Dual Damper Smoke Extractor (#593001)

Affected Products: Gas smoker models; BBR series - 79 & 700
SPK series - 280,500*,700,1400**
XLR series - 350,600,1000,1400,1600 & 1600-4
UXR series - 100
* 500 smokers without "K" in the serial number
** 1400 smokers built prior to 2016.

The dual damper smoke extractor (#593001) is now obsolete.

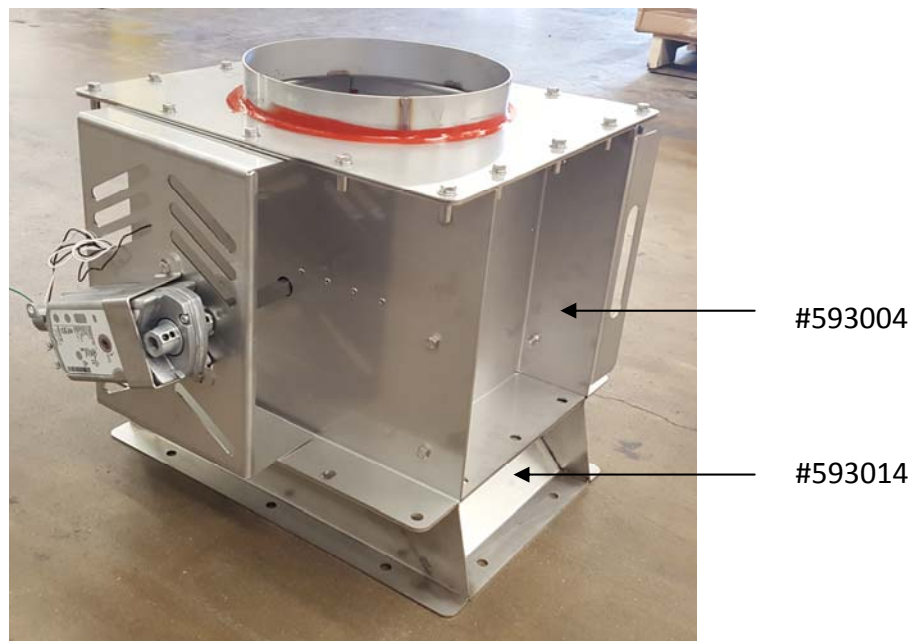
The single removable damper smoke extractor (#593004) can be installed on units that were equipped with the dual damper smoke extractor (#593001) with the use of adaptor (#593014) . This is pictured below:

Actions Required (continued): The single damper smoke extractor is 2 1/4" (57mm) taller than the dual damper smoke extractor and the adapter is 4" (102mm) tall, this will require some adjustment to the length of the exhaust duct. The actuator motor of the single damper smoke extractor does not have a port for the conduit connection for the smoke extractor exhaust fan; some modification will be required.
